RE: Feedback on draft Street Design Manual

STREET DESIGN MANUAL

Urban Development Institute of Australia Queensland Comments

2.6	SENSE OF PLACE, COMMUNITY AND SAFETY		
	Strategy 2.6.4		Improve wayfinding with additional sign for residential streets:

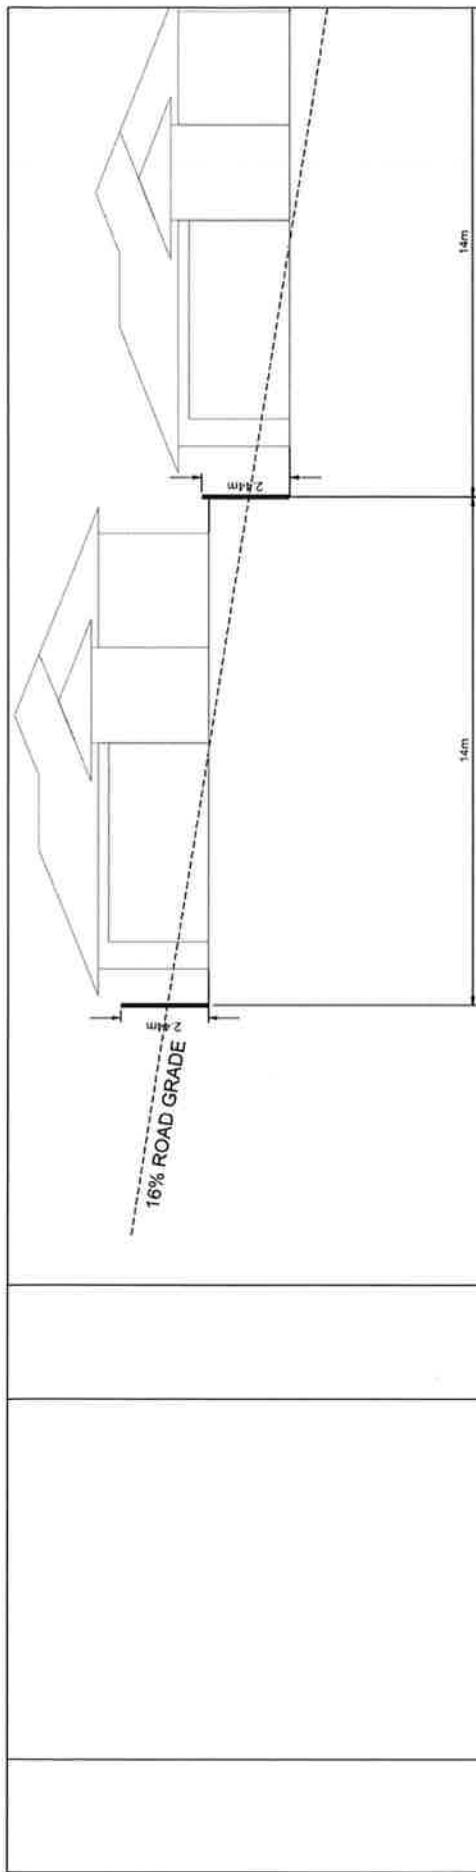
<p>MORE WORK COULD BE DONE HERE TO ASSIST PEDESTRIAN THOROUGHFARE.</p> <p>EXAMPLE : OF STREET SIGNAGE THAT SHOW THE LINKING OF STREETS.</p>
	Strategy 2.6.7	25	<p>Suggested solution to improve wayfinding for pedestrian traffic.</p> <p>Confirm if target speed is the same as posted speed to ensure speed environment is aligned with street type.</p>
